**CHANGE ORDER**

ORDER NO.: 4  
DATE: December 10, 2020  
AGREEMENT DATE: April 3, 2019

NAME OF PROJECT: Wilbarger Creek Wastewater Treatment and Collection System Improvements

**RE: Wilbarger Creek Wastewater Treatment And Collection System Improvements  
CPR 020 – Bearing Walls**

PLAN E.2.18 LIGHTING PLAN - ADMIN OFFICE

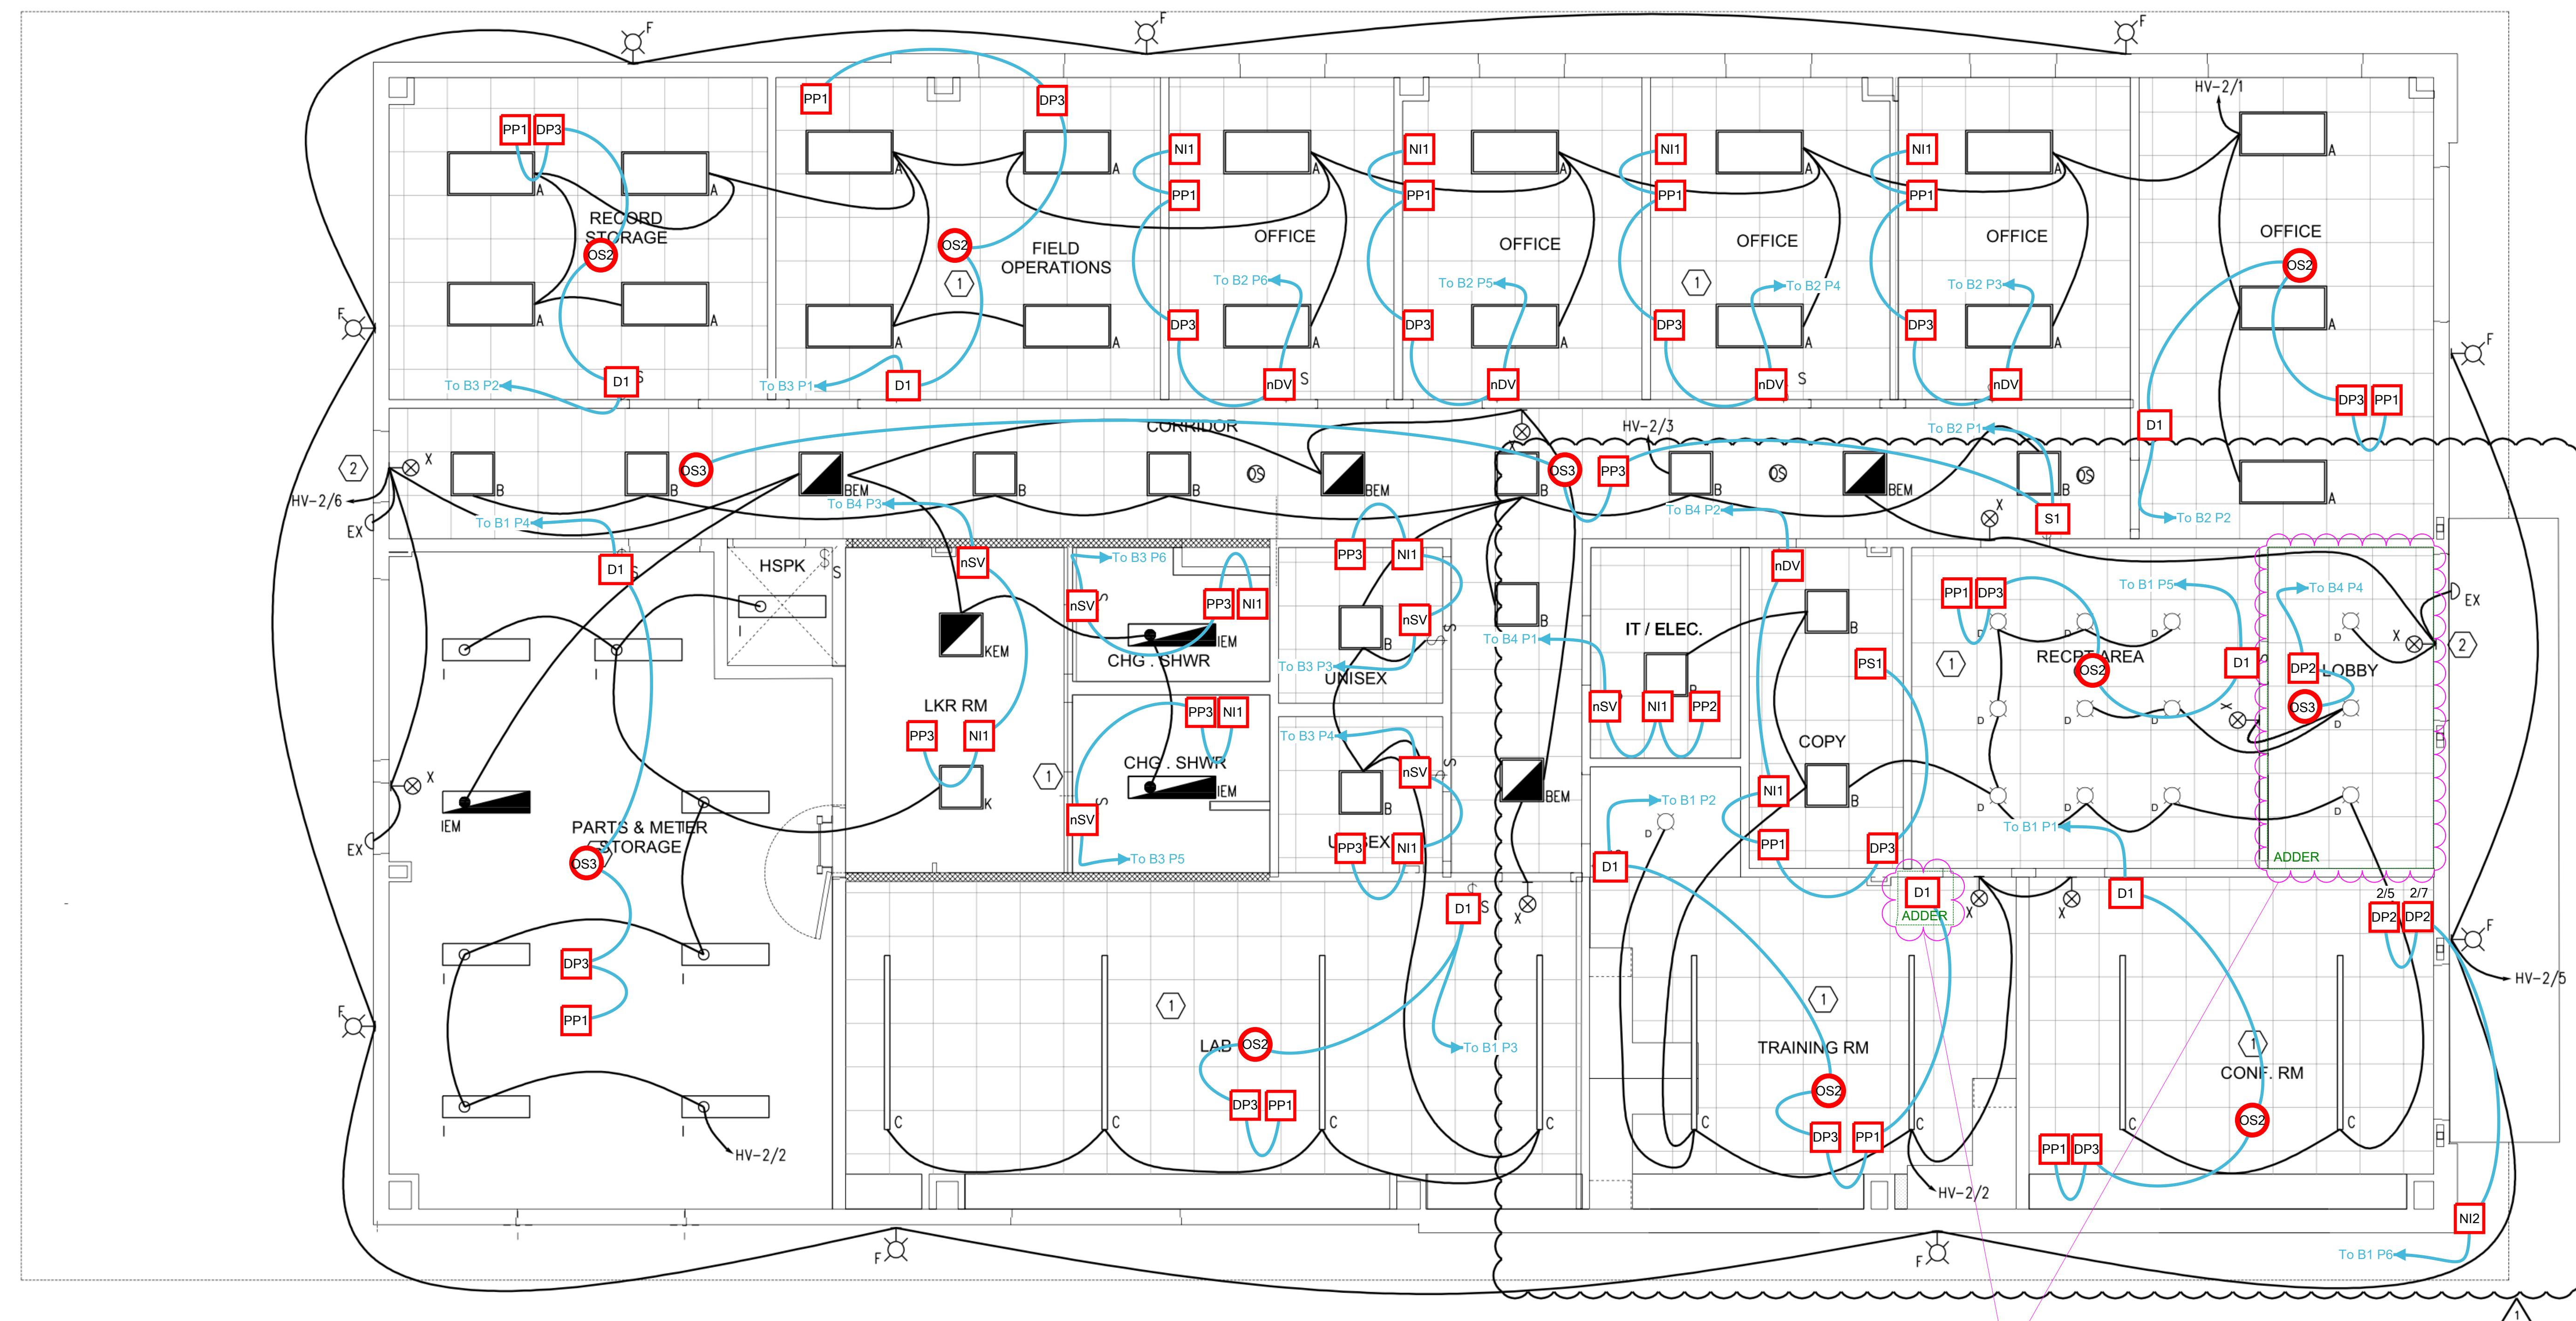
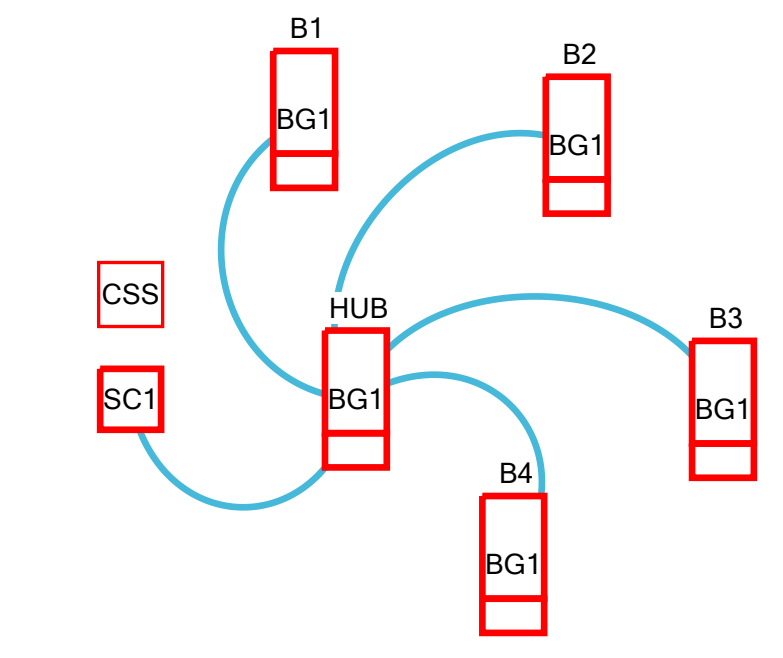
- Revised Sheet E.2.15 – Additional Conduit & Jbox
- Revised Sheet E.2.16 – Additional Conduit, Wire, Telecom/Data Recp, & Interior Jbox.
- Revised Sheet E.2.17 – Additonal Smoke Detector & Re-submit Fire Alarm Drawings.
- Revised Sheet E.2.18 – Additional Lighting fixtures & Controls.

NCM PDT 10 AR RJB + NPP16 D EFP  
USPOM ADDED FOR LOBBY.  
NEW NPQDM DX WH USPOM ADDED  
FOR TRAINING ROOM.
